ZH3

ZH3 ASSY P/N :31ZH3MB0008
ZH3 MB C/S ASSY P/N: 41ZH3CS0001
ZH3 MB S/S ASSY P/N: 51ZH3SS0003

Size	Document Number ATHLON64 HT I/F	Rev D
Date:	Tuesday, June 27, 2006	Sheet 3 of 36

SB460 SB 27x27mm

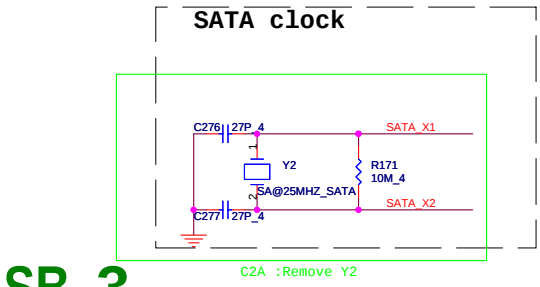
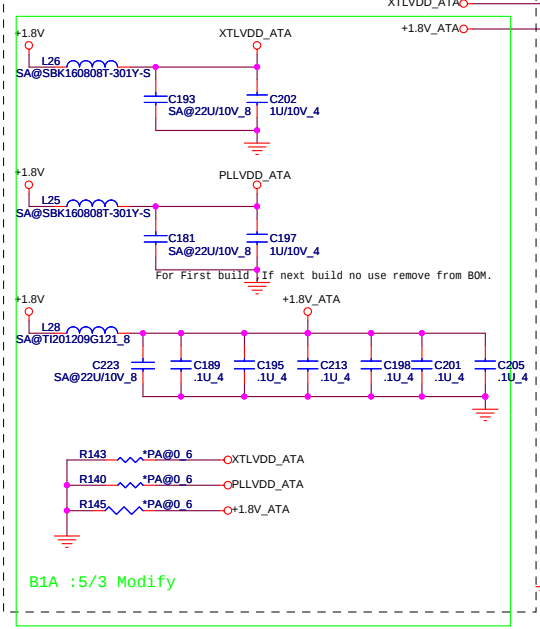
C2A :Remove Y2

LAN BCM5788:
AD20 REQ2#
GNT2# INTG#

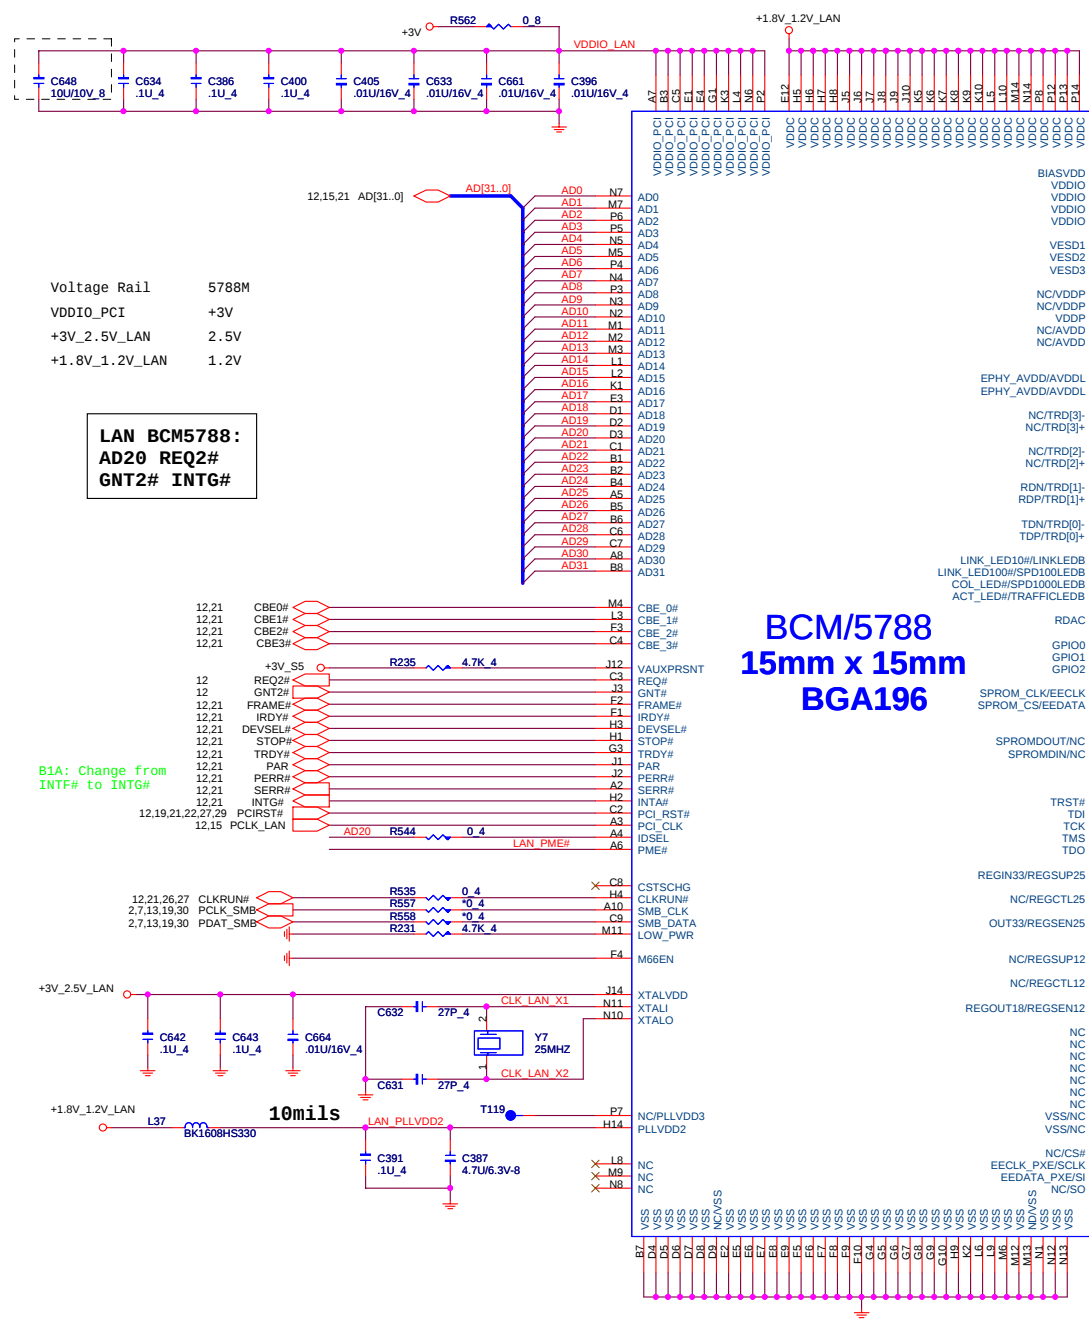
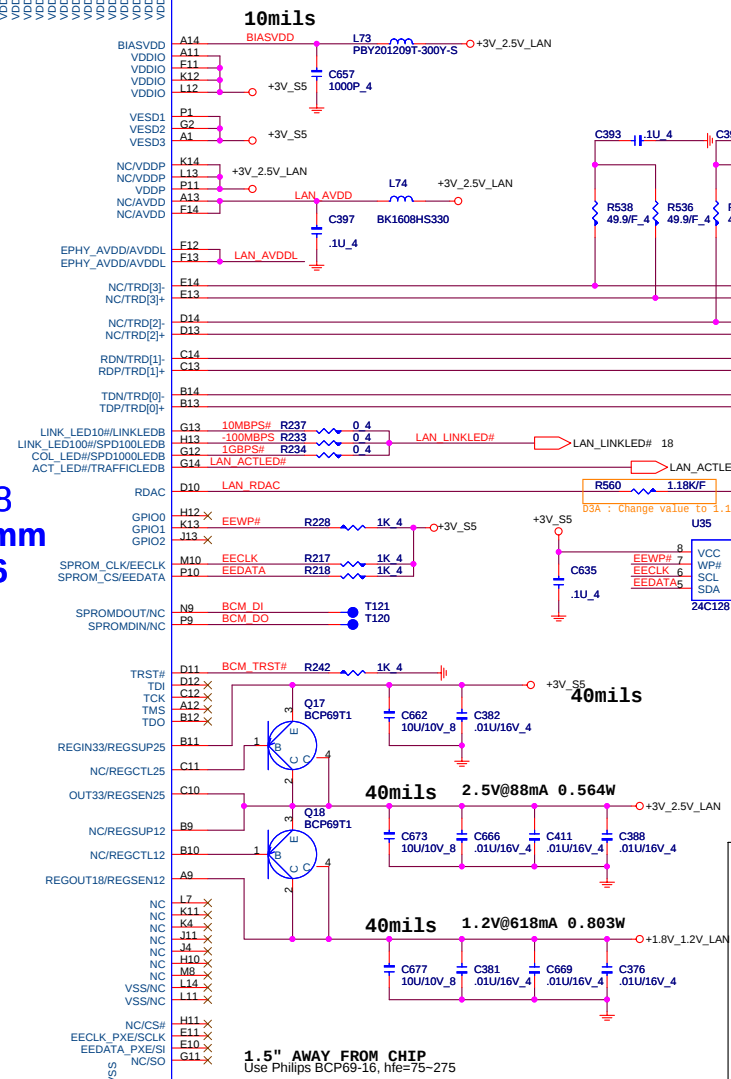
B1A: Change from
INTF# to INTG#

WLAN MINI CARD

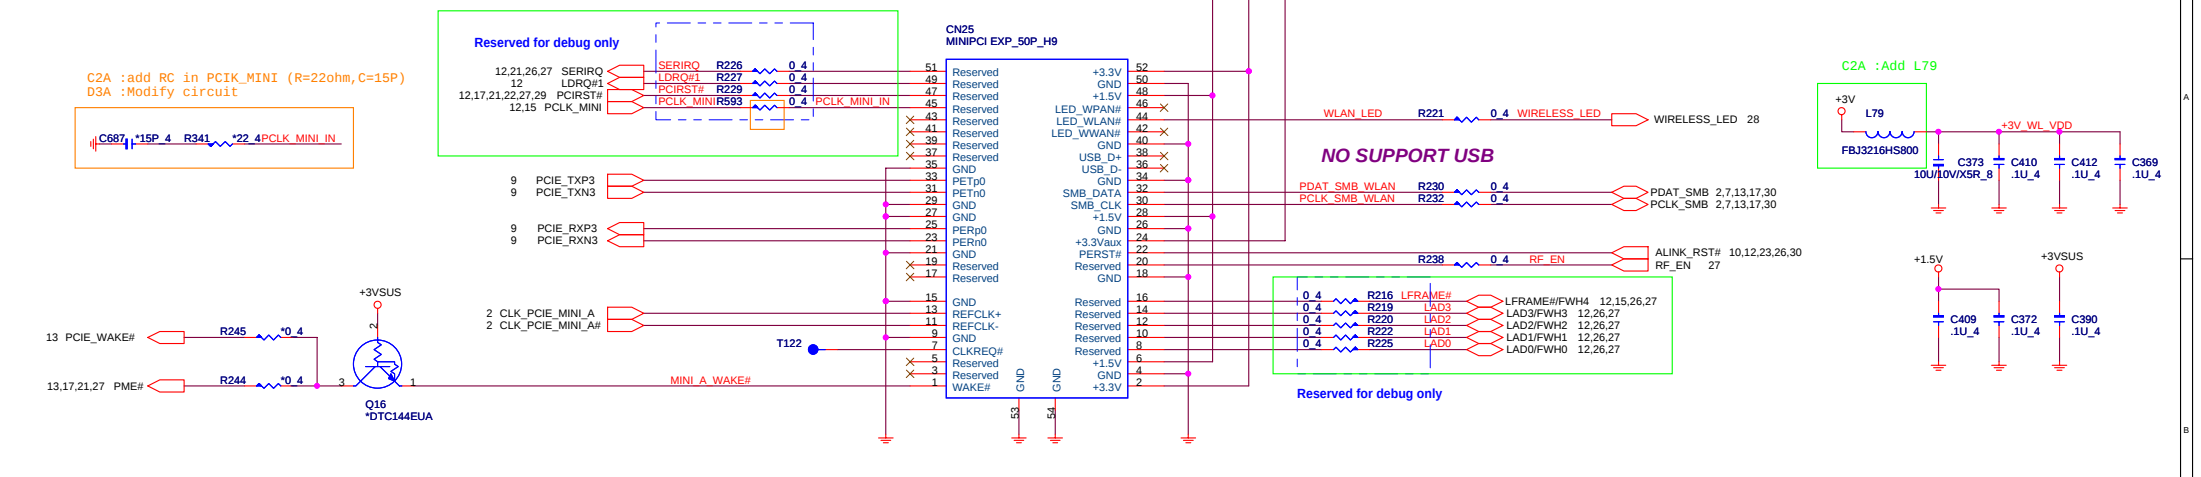
B1A:These signals of reserve have be used by wireless module of Foxconn B6. These signals impact LPC. I remove signal line in order to solve the WLAN issue.

SIO (87383) & FIR

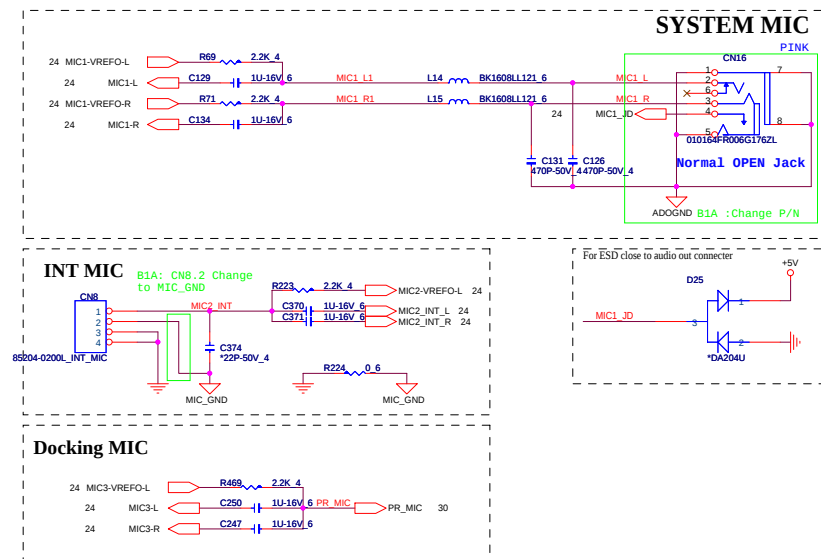
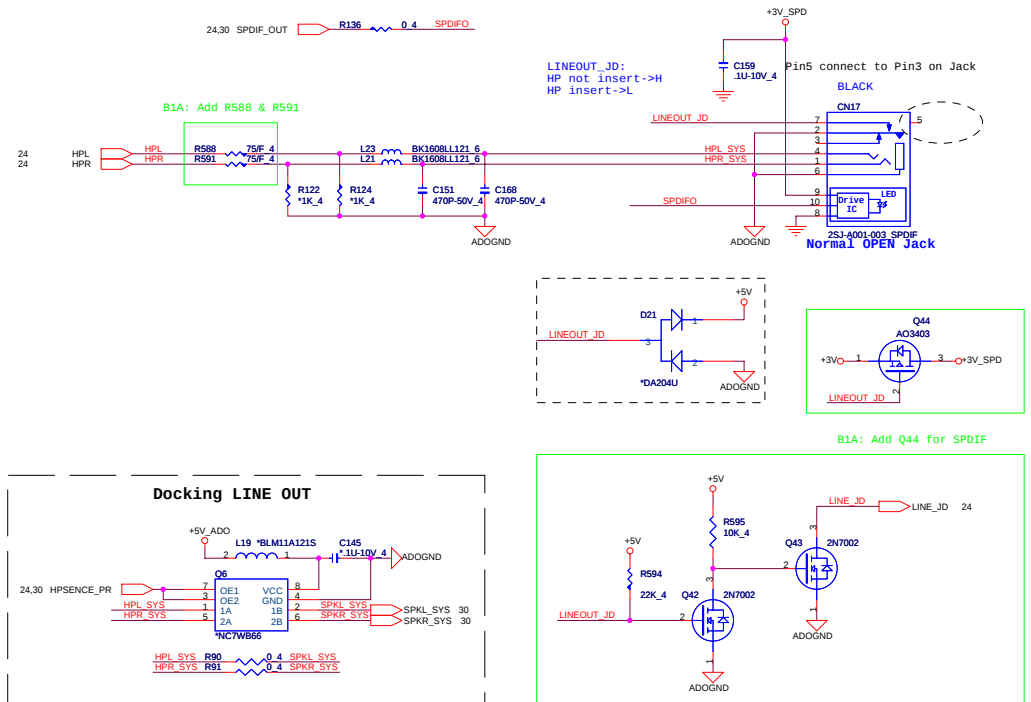
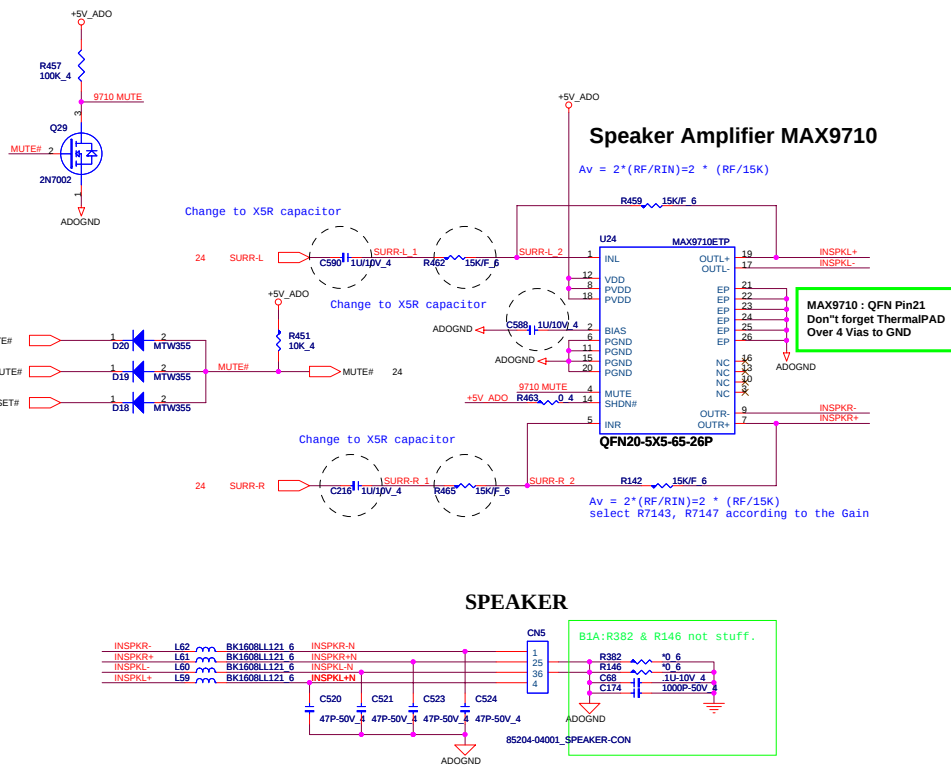
B1A:Stuff R552,set PC87383 I/O to 2E/2F

B1A :Change to 0 ohm

Size	Document Number	Rev
	CPU CORE MAX8760	D
Date:	Tuesday, June 27, 2006	Sheet 31 of 36

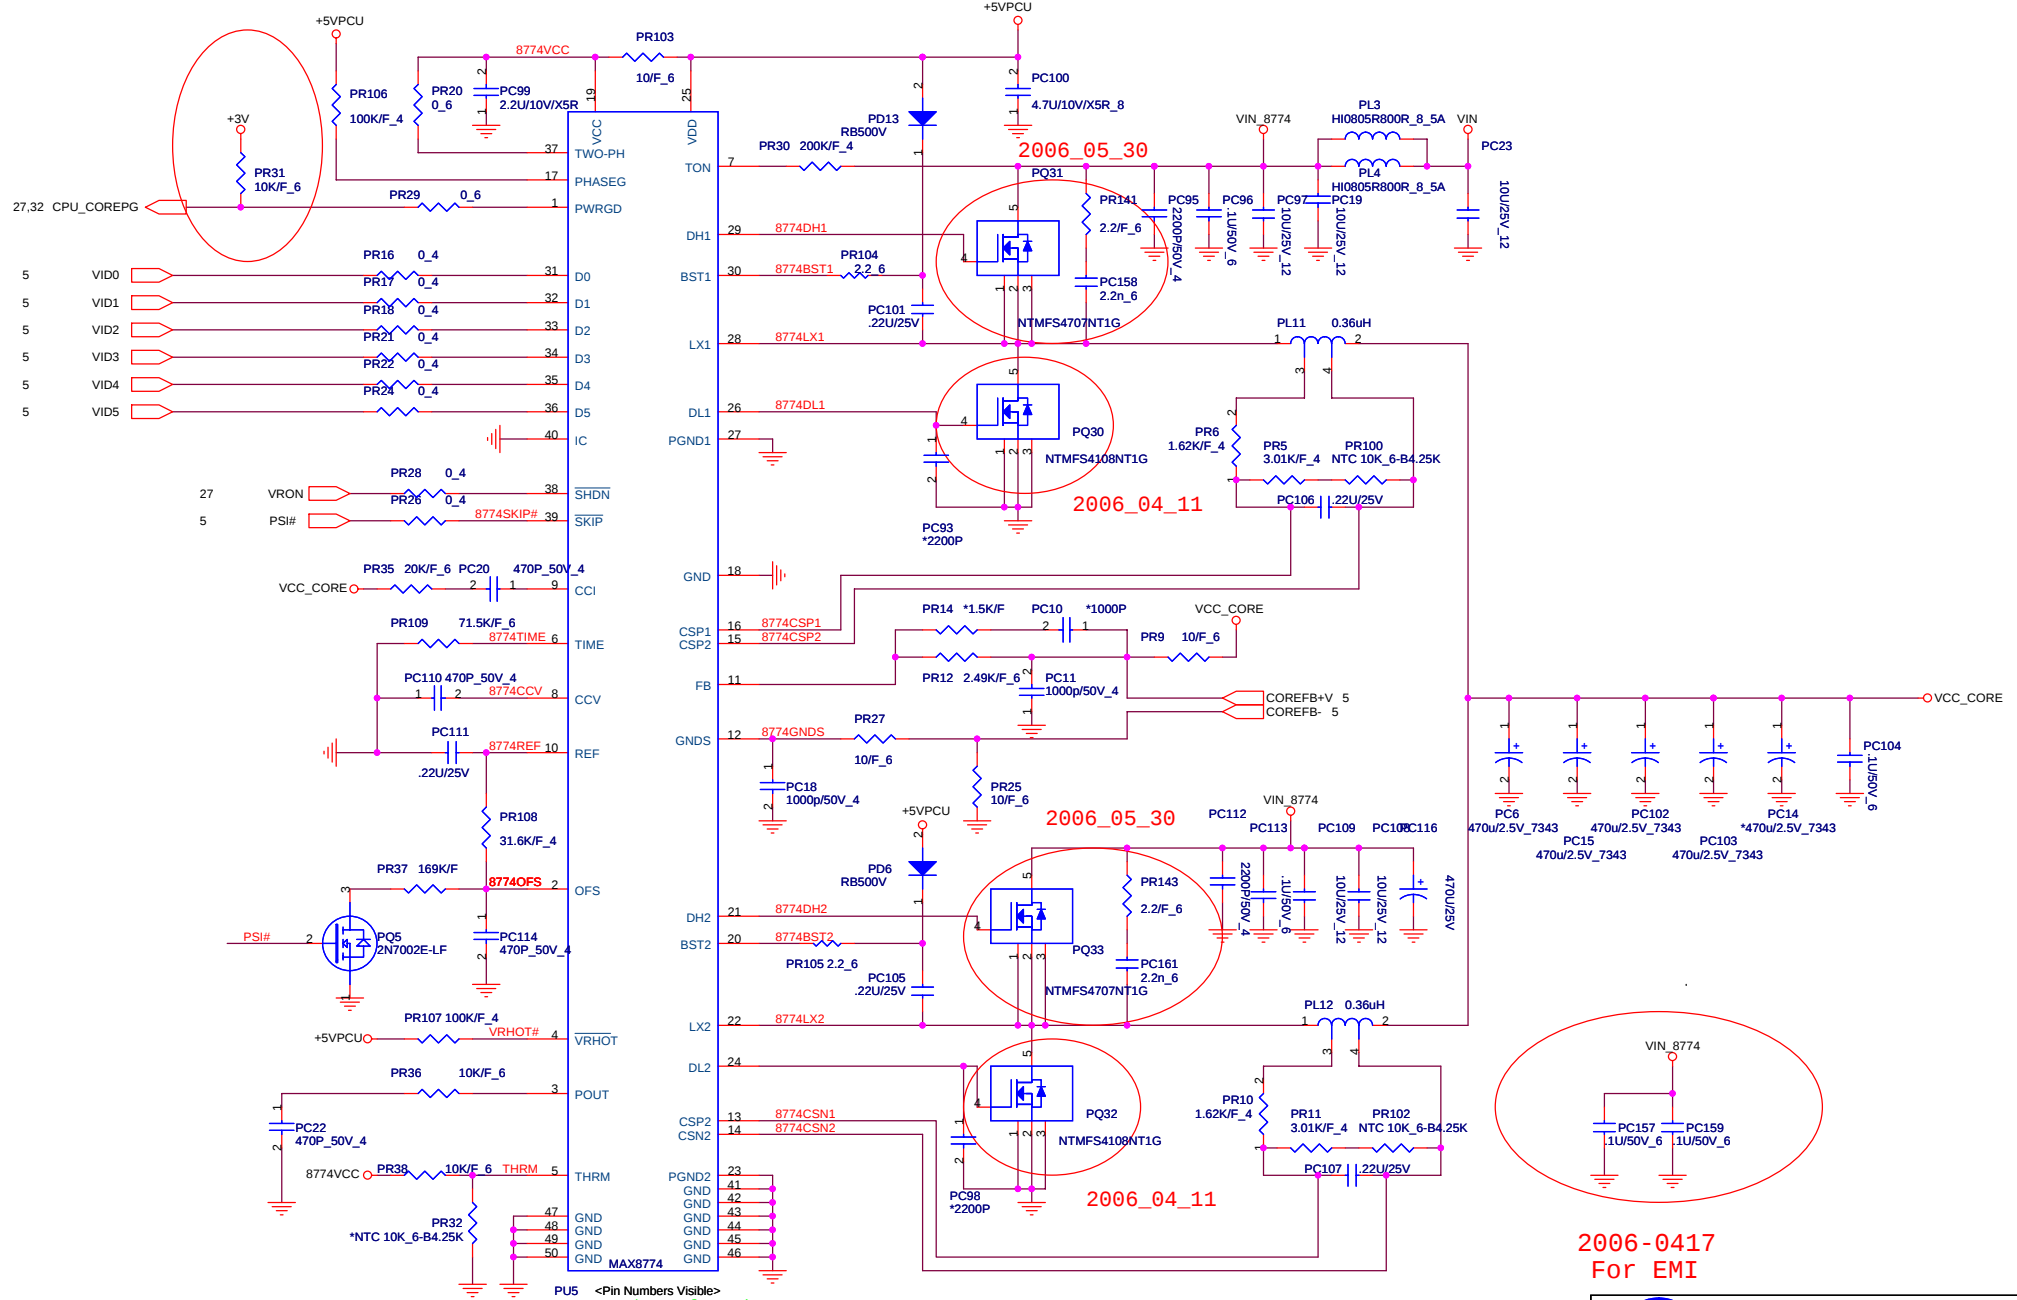
PUS <Pin Numbers Visible>
B1A:PUS Change footprint to -50P

2006-0417
For EMI

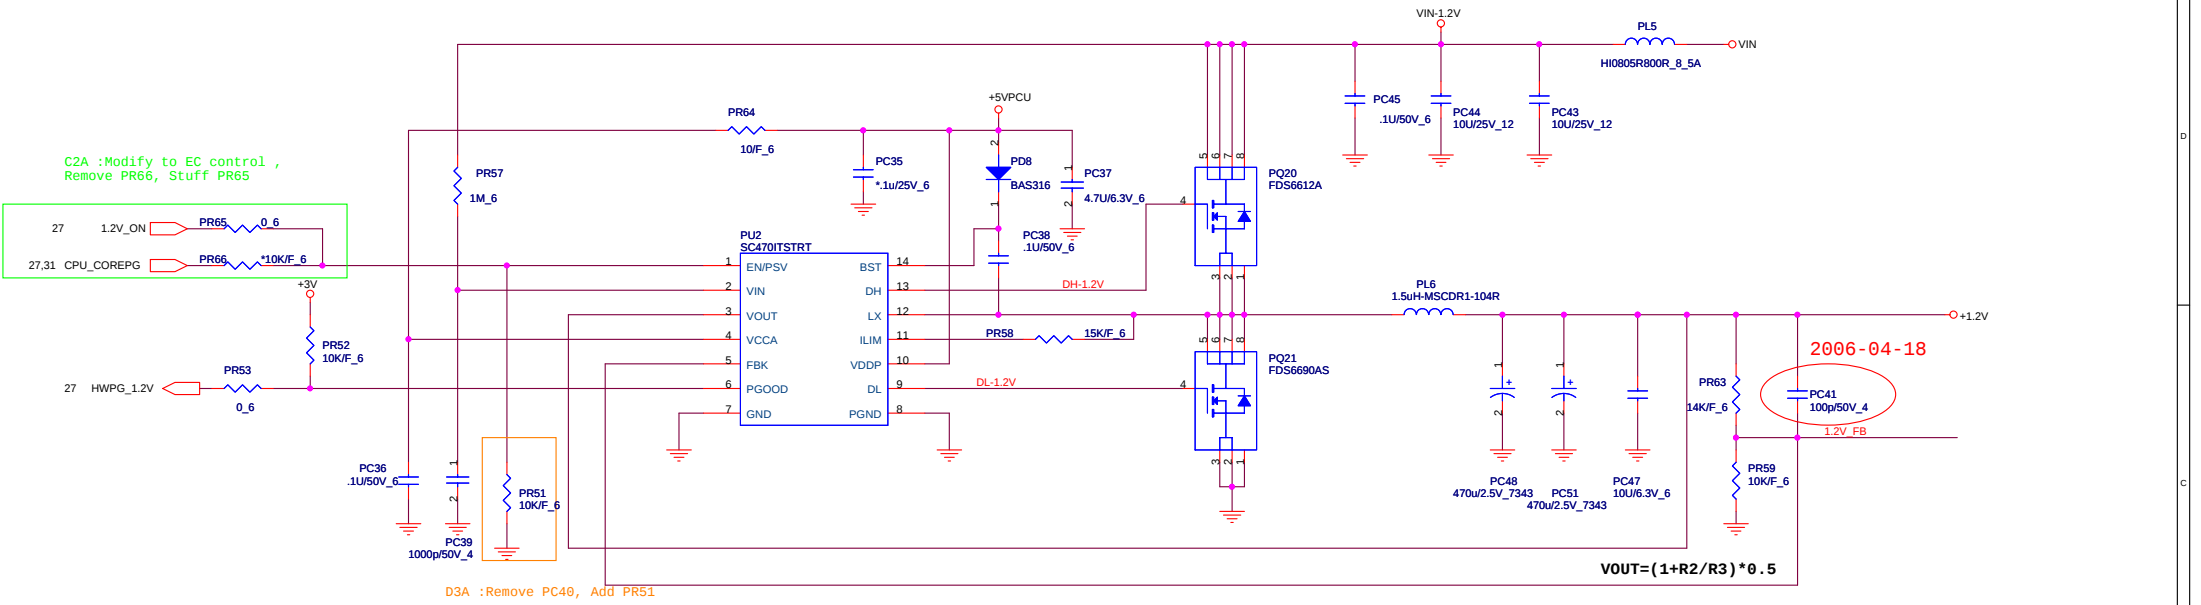
C2A :Modify to EC control ,
Remove PR66, Stuff PR65

change from NCP5214 to SC480IMLTRT
